ADDENDUM #1

Project: Orchard Cove Renovation
Project No: 20170714

From: Peter Johansen
Date: May 15, 2018

Orchard Cove Renovation

EC601

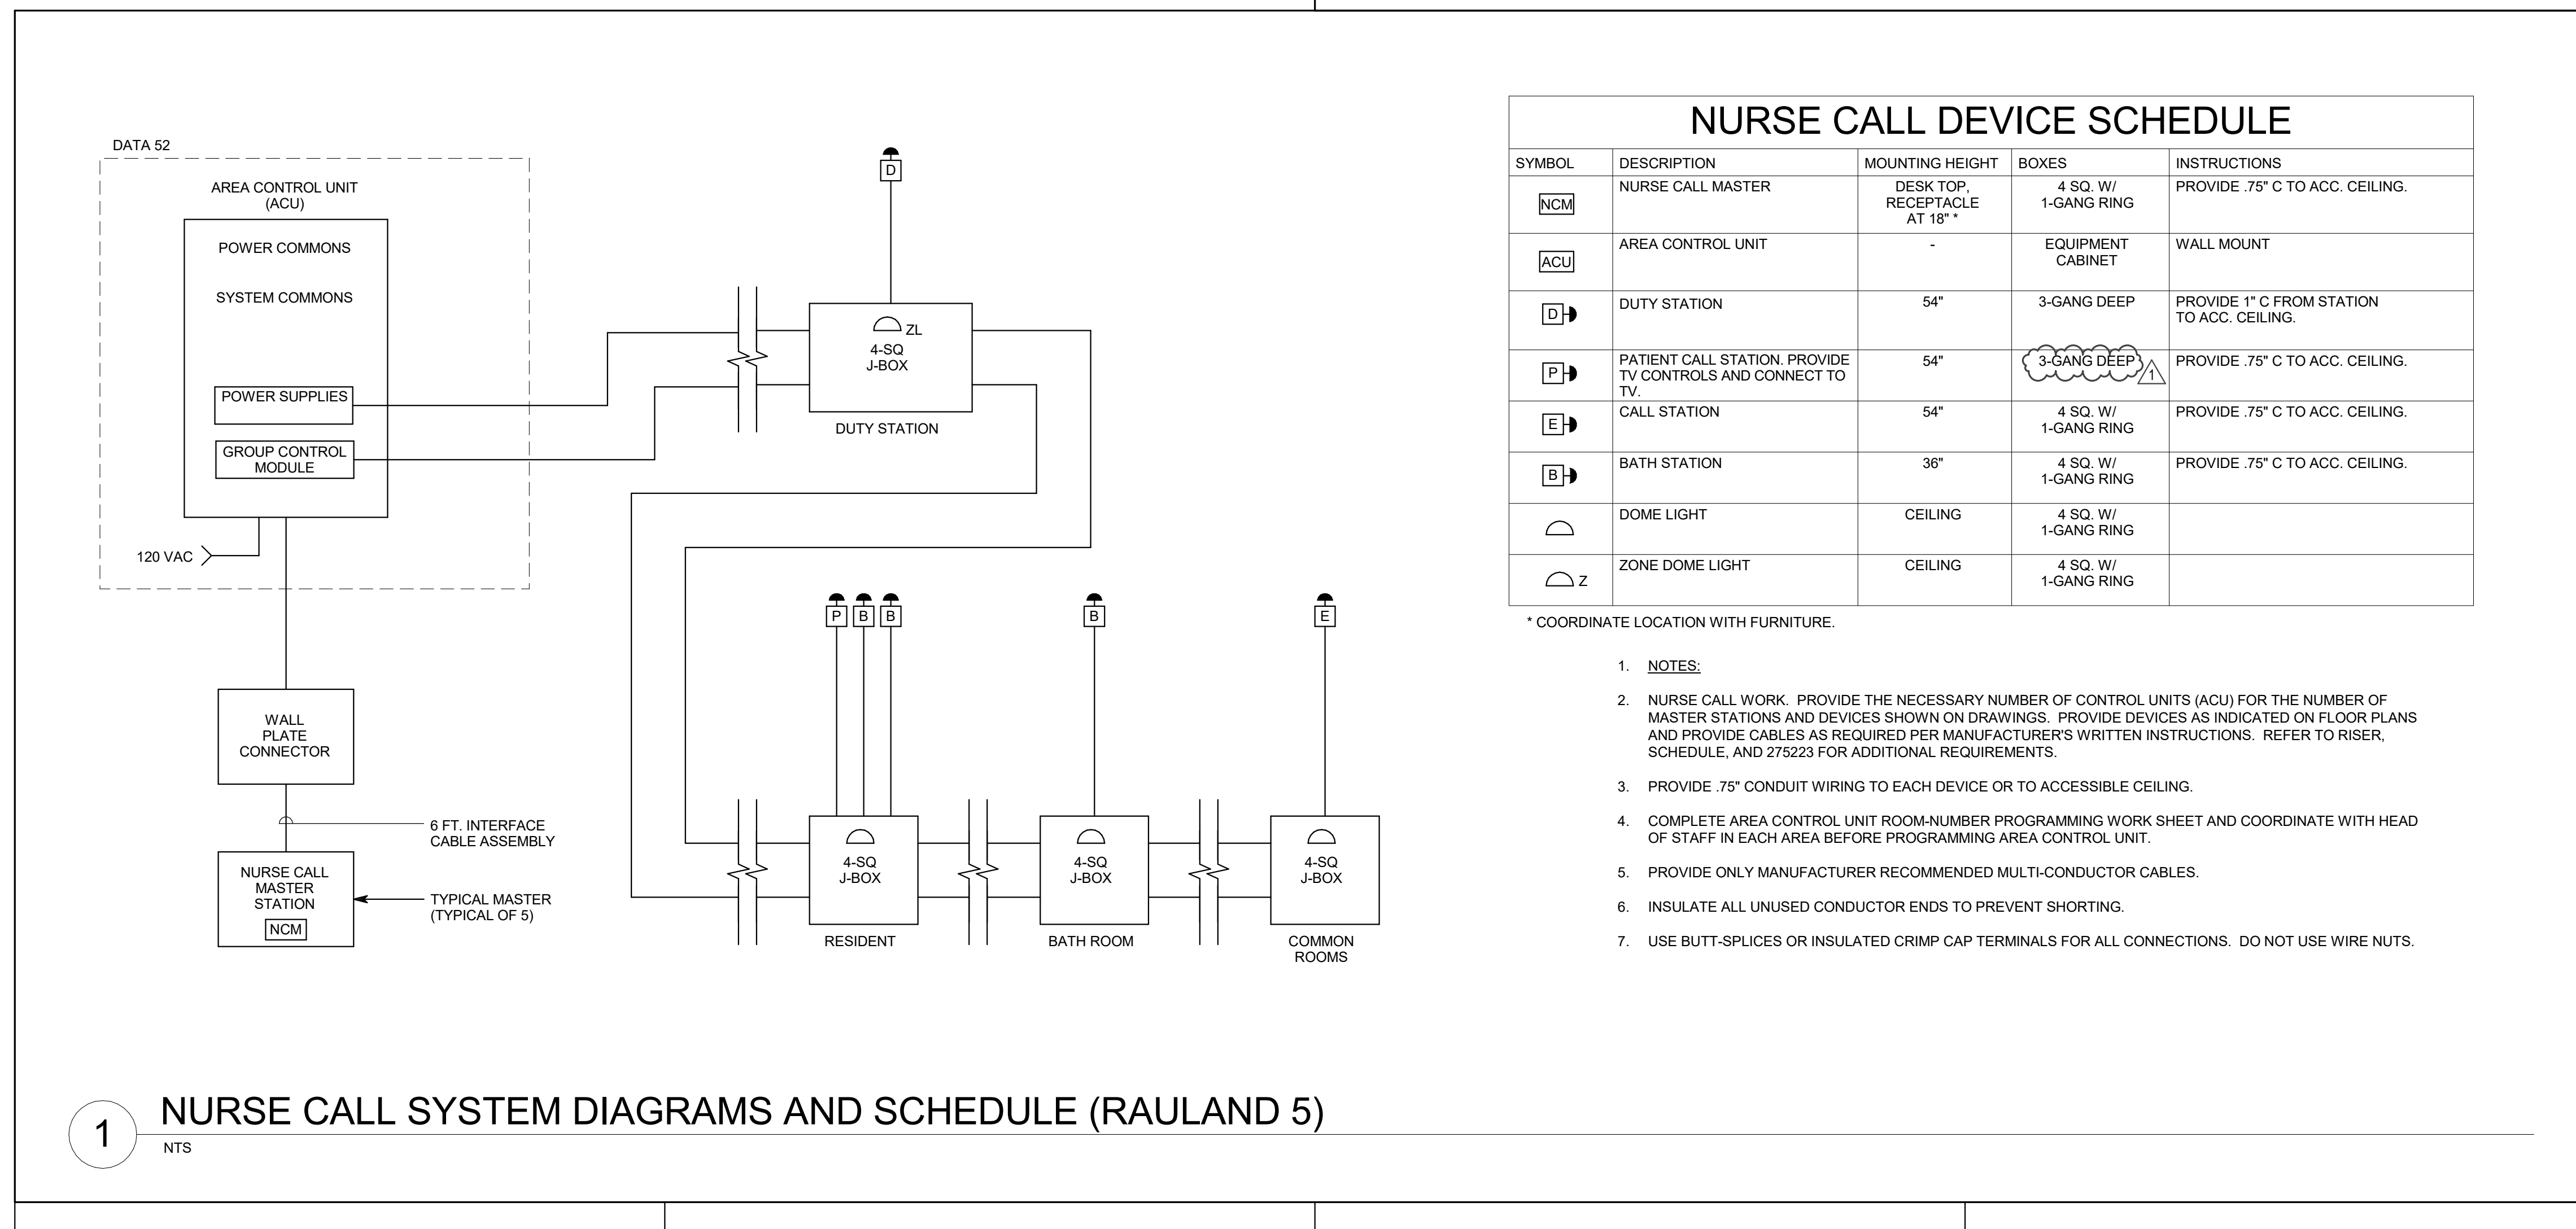
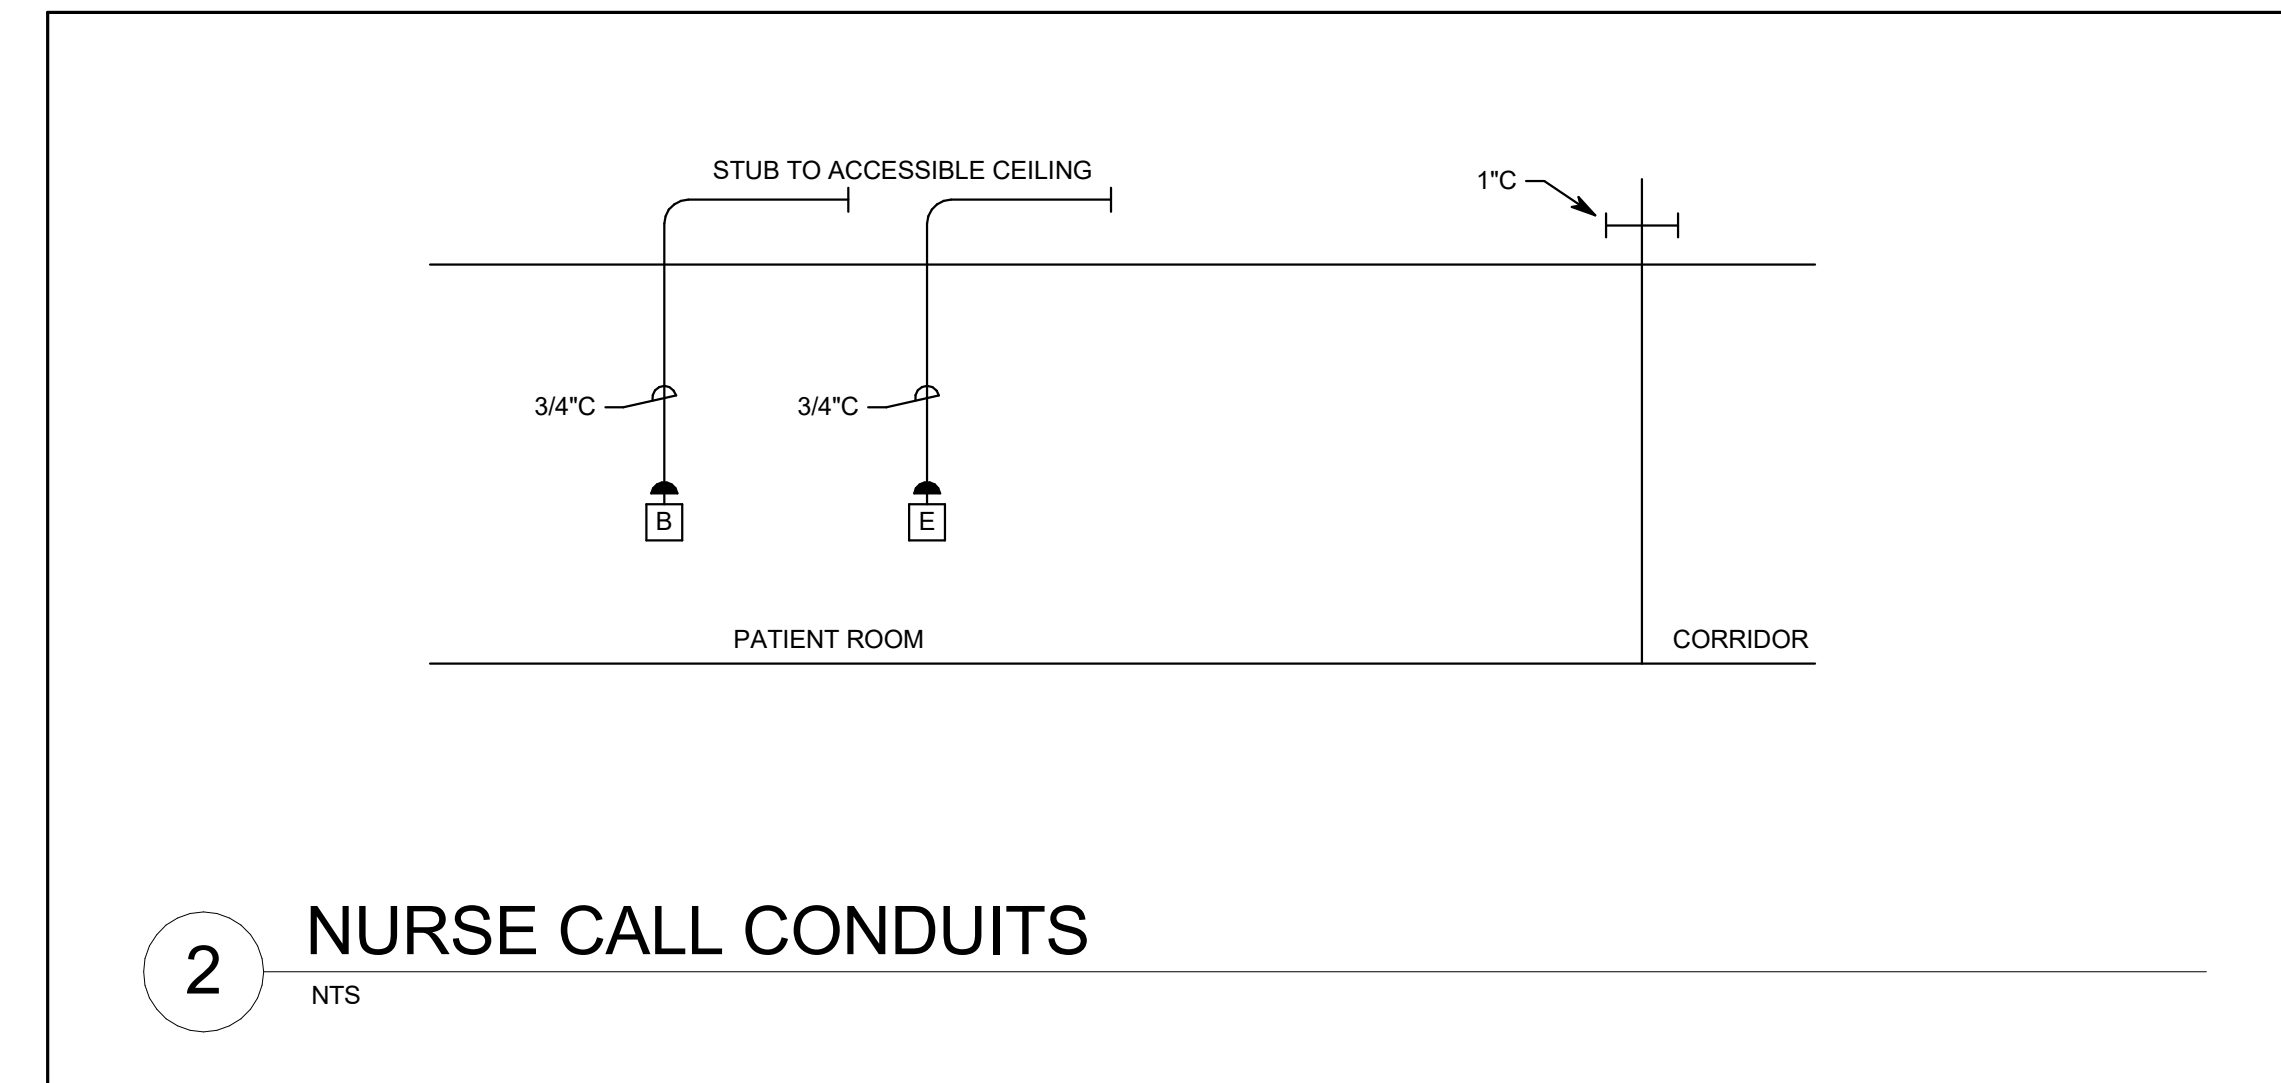
EC601 (See attached sheet)

1. Changed the rough-in requirements for the patient stations to a 3-gang deep box.
